SUBJECT: EDWIN I. HATCH NUCLEAR PLANT, UNITS 1 AND 2 RE: ISSUANCE OF  
AMENDMENTS (TAC NOS. MA9119 AND MA9120)

AMENDMENT TO FACILITY OPERATING LICENSE

Amendment No. 222  
License No. DPR-57

SAFETY EVALUATION BY THE OFFICE OF NUCLEAR REACTOR REGULATION  
RELATED TO AMENDMENT NO. 222 TO FACILITY OPERATING LICENSE DPR-57  
AND AMENDMENT NO. 163 TO FACILITY OPERATING LICENSE NPF-5  
SOUTHERN NUCLEAR OPERATING COMPANY, INC., ET AL.  
EDWIN I. HATCH NUCLEAR PLANT, UNITS 1 AND 2  
DOCKET NOS. 50-321 AND 50-366

Figure 3.4.9-1 (page 1 of 1)  
Pressure/Temperature Limits for  
Inservice Hydrostatic and Inservice Leakage Tests

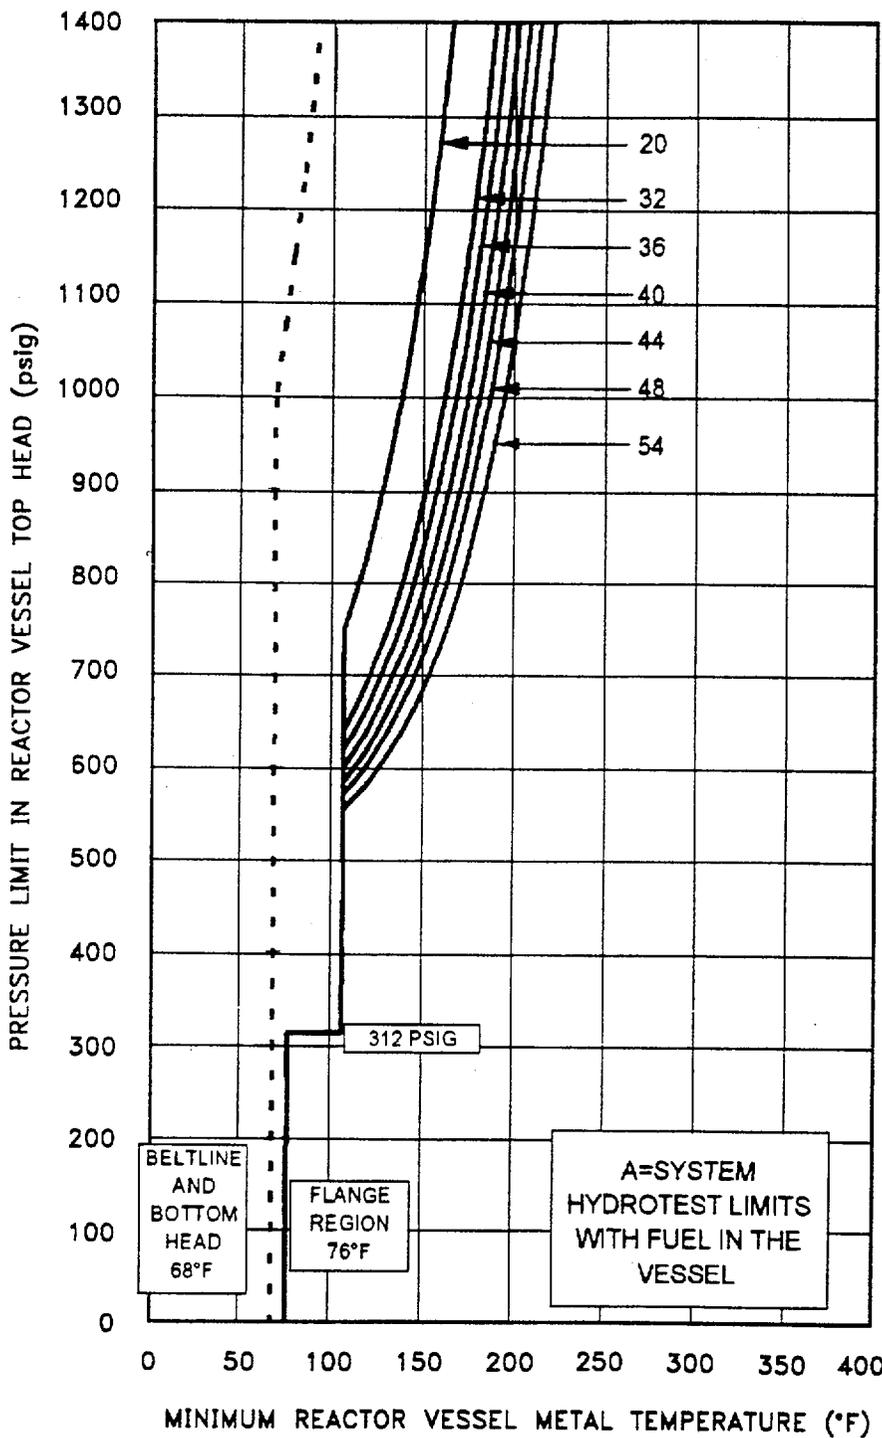
The amendments revise the reactor vessel pressure and temperature limit curves that are in the Technical Specifications. In addition, an exemption from Title 10 of the *Code of Federal Regulations* (10 CFR) Part 50, Appendix G was processed in conjunction with these amendments and issued separately.

INITIAL RTndt VALUES ARE  
-20°F FOR BELTLINE,  
40°F FOR UPPER VESSEL,  
AND  
10°F FOR BOTTOM HEAD

HEATUP/COOLDOWN  
RATE 20°F/HR

BELTLINE CURVES  
ADJUSTED AS SHOWN:  
EPPY SHIFT (°F)  
20 130.7

BELTLINE CURVES  
ADJUSTED AS SHOWN:  
EPPY SHIFT (°F)  
32 154.6

BELTLINE CURVES  
ADJUSTED AS SHOWN:  
EPPY SHIFT (°F)  
36 161.0

BELTLINE CURVES  
ADJUSTED AS SHOWN:  
EPPY SHIFT (°F)  
40 167.5

BELTLINE CURVES  
ADJUSTED AS SHOWN:  
EPPY SHIFT (°F)  
44 173.7

BELTLINE CURVES  
ADJUSTED AS SHOWN:  
EPPY SHIFT (°F)  
48 179.4

BELTLINE CURVES  
ADJUSTED AS SHOWN:  
EPPY SHIFT (°F)  
54 187.2

The staff concludes that the proposed P-T limits for the reactor coolant system for heatup, cooldown, hydrotest, and criticality satisfy the requirements in Appendix G to Section XI of the ASME Code, as modified by Code Cases N-588 and N-640, and Appendix G of 10 CFR Part 50 for a series of specified EFPYs up to 54 EFPYs for both Hatch units. The proposed P-T limits also satisfy GL 88-11, because the method in RG 1.99, Rev. 2 was used to calculate ART. Hence, the proposed P-T limit curves may be incorporated into the Hatch, Units 1 and 2 TSs.
